Memorandum

Date: May 20, 2025	
To: Brian Froelich, AICP	Organization: City of Capitola
From: RRM Design Group	Title: Design Review Team
Project Name: Capitola On-Call Architectural and Landscape Review	Project Number: 1783-10-PP24
Topic: 2178 41 st Avenue Review

Project documents reviewed include the 2178 41st Ave. Capitola-Drawings Set in 10 pages; Site Plan, Sheet SDI; Site Lighting Photometric, Sheet SDI-L; Site Details, Sheet SD2; Landscape Plan, Sheet LAI; Topographic Survey, Sheet 1 of 1; Preliminary Grading and Utility Plan, Sheet 1 of 2; Stormwater Control Plan, Sheet 2 of 2; Floor Plan, Sheet A1.1; Roof Plan, Sheet A1.5; Exterior Elevations, Sheet A2.1.

Site Plan

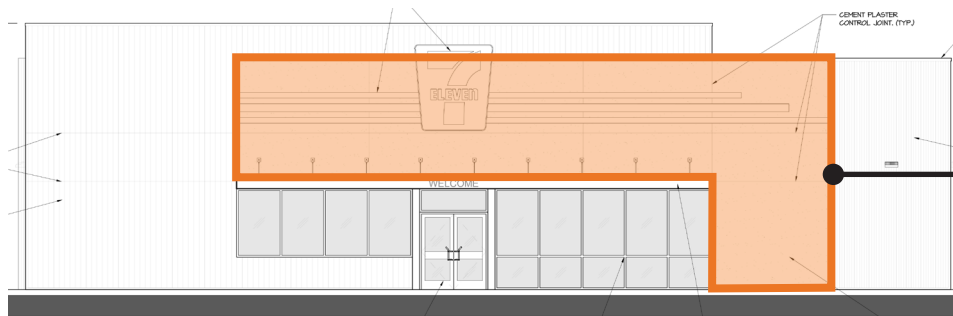
Site planning involves an understanding of appropriate building placement and configuration, but also the consideration of topography, surrounding uses, landscape design, adjacent uses, hardscape, and parking. The project proposes to demolish the existing convenience store and construct a new, larger convenience store pushed closer to the rear property line. The existing drive aisles and parking spaces will be re-organized and re-striped to accommodate the new convenience store location. Adequate on-site pedestrian pathways are provided that connect the primary entrance to the public sidewalk via a striped crosswalk and raised private walkway running along the northern property line. The applicant successfully provided new planter areas with landscaping near the parking spaces adjacent to the proposed convenient store entrance that enhance the overall site appearance. The applicant may consider reducing the number of bollards located between the proposed parking spaces and walkway running along the primary entrance or alternatively incorporating wheel-stops to avoid the need for the large amount of bollards currently shown.

Consider replacing bollards with wheel-stops or reducing number of bollards to improve the physical appearance of the proposed structure from the public realm.

1. Consider replacing the large amount of bollards situated between the parking spaces and primary entrance walkway with wheel-stops.

West Elevation

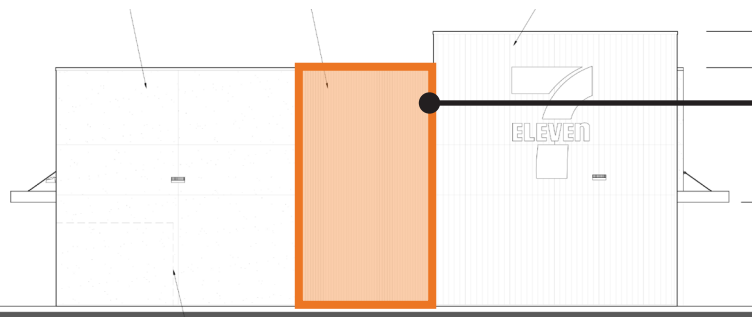
Building massing, or the way the building is sized and appears, is a primary and important component of building design. In review of the elevations provided on Sheet A2.1, the applicant has incorporated minimal massing strategies to remove the current “box-like” appearance of the proposed structure. The west elevation provides variation in massing through a change in wall plane height and the applicant may consider a similar strategy on the east elevation facing single-family residential uses to further improve the projects appearance to neighboring dwelling units (CMC 17.120.070 B). Additionally, the applicant may consider furring-out wall planes more than 6 inches when transitioning materials to ensure all materials terminate at-inside corners and further break-up the proposed structure on all elevations (CMC 17.120.070 H).

Explore projecting wall planes more than 6 inches when transitioning between materials to ensure material transitions occur at inside corners to remove a tacked on appearance and further break up the proposed structure.

2. Consider applying a change in wall plane height on the east elevation to provide variation and break up the current “box-like” appearance.
3. Consider furring-out wall planes more than 6 inches when transitioning materials to ensure all materials terminate at inside corners and further break-up the proposed structure on all elevations (CMC 17.120.070 H).

East Elevation

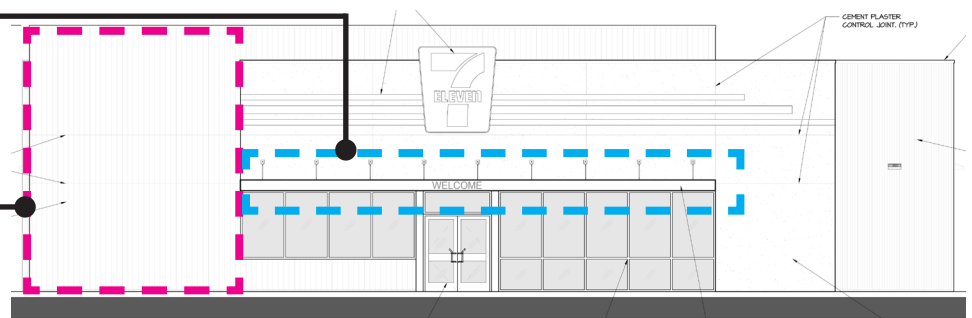
Incorporate an additional color or material on the east elevation to further articulate the elevation and improve the view for adjacent single-family dwellings.

Reduce the “box-like” appearance through the addition of a change in wall plane height on the east elevation, similar to the change in wall plane height shown on the west elevation.

Articulation represents change in the form of a building expressed through proportion, details, wall plane changes, heights, and other design elements. The applicant has adequately articulated the west elevation of the proposed structure through the application of differentiation in colors and materials and incorporation of a stylistically consistent awning defining the primary entry. However, the applicant should explore opportunities to carry the articulation strategies onto the east elevation to remove the blank wall appearance facing the single-family dwellings (CMC 17.120.070 J).

Roof forms are critical elements in providing visual interest within a project and reinforcing architectural style. The applicant is proposing to use a flat roof style with 3'-3" parapet to introduce variation in the roof line appearance, generally considered consistent with the proposed architectural style. To establish a sense of variation along the east elevation roof line, the applicant may consider incorporating parapet, similar to the usage on the west elevation, to break up the current monotonous appearance of the unbroken roof line.

4. Explore opportunities to carry the articulation strategies depicted on the west elevation onto the east elevation to remove the large blank wall currently visible from adjacent single-family dwellings (CMC 17.120.070 J).

5. Consider incorporating the parapet shown on the west elevation, onto the east elevation, to establish a change in roof line and create a sense of variation.

7. Consider applying additional windows above the primary entry canopy to increase transparency and establish a connection with the public realm.
8. Revise the east elevation by removing the current depiction of a large blank wall facing the adjacent single-family dwellings by applying additional colors or materials such as the “Burned Slate Corrugate Metal Panel or “Cedar” Fiber Cement Siding (CMC 17.120.070 K).

West Elevation

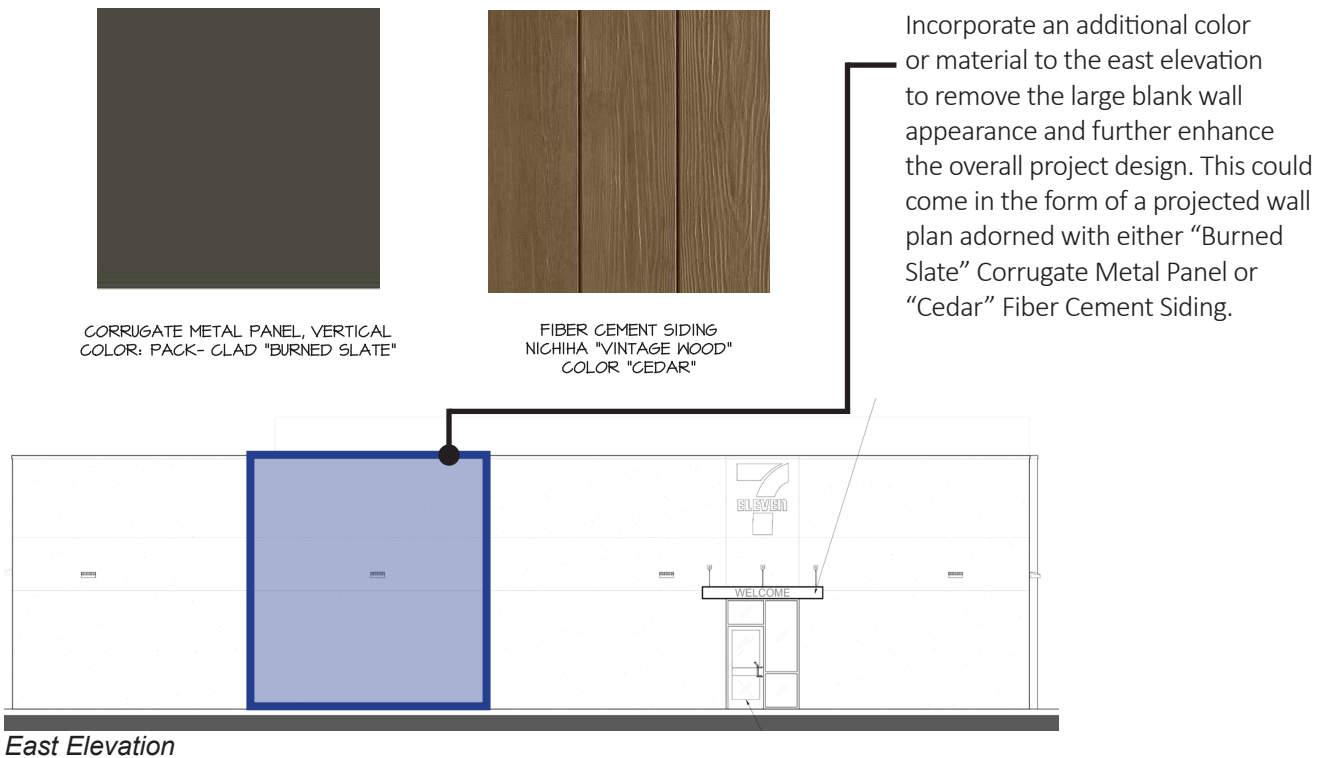
A primary entry contributes to the overall identity of a building by defining the architectural style and engaging with the public realm. The primary entry is provided on the street facing west elevation, defined by a covered awning and surrounded by large transparent windows. While the applicant has begun to define the primary entry, the project design could benefit from further accentuation of the canopy through enlargement or further incorporation of the canopy into the proposed signage, similar to the design interventions shown on 7/11's reflecting the updated architectural corporate branding. Alternatively, the applicant may consider relocating and enlarging the 7/11 sign to the open space shown on the left side of the elevation to establish a connection with the public realm and improve the project design.

Further enhance the primary entry and west elevation through accentuation of the proposed canopy.

Alternatively, relocate the 7/11 sign to enhance the overall elevation.

Example of Alternative Placement of 7/11 Sign to Enhance the Overall Elevation with a Stylistic Design.

7/11 Primary Entry Example with Signage and Canopy Integrated to Clearly Define the Primary Entry to Patrons and Windows Applied Above the Canopy to Provide Further Transparency.

6. Explore ways to further accentuate the primary entrance to increase visibility from the public realm. This could come in the form of incorporating the entry canopy with the 7/11 signage to further define the primary entry or relocate the 7/11 to open space on the left side of the elevation and enlarging the sign.
